Authors' response to reviewer 1

Authors' response to reviewer 2

Authors' response to reviewer 3

Figure 1: Irregular wave frequency range $T_p = 9s$

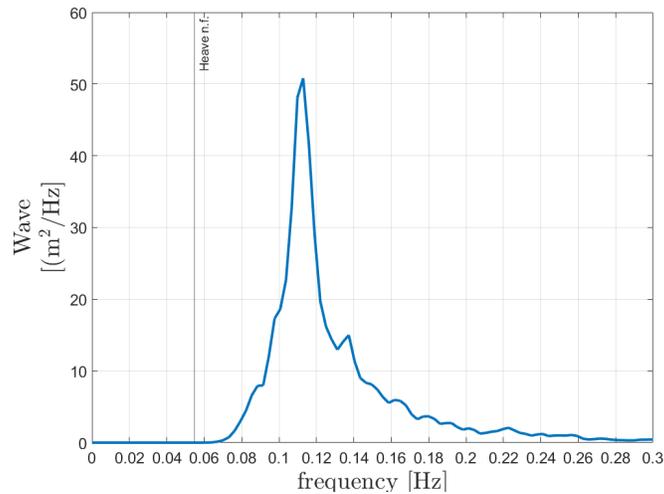
Table 10: Is there concern with the coalescence of the heave natural frequency for Activefloat with waves?

The heave natural period is much higher than the peak wave period (T_p) in the Gran Canaria islands which is between 6 s at normal operations and 9 s at extreme conditions, hence the heave natural frequency lies outside of the wave frequency range. We have not seen any concerning responses in any load case, and we believe there is no coalescence. Figure 1 shows Activefloat's heave natural frequency with the vertical line, and the wave frequency range for $T_p = 9s$.
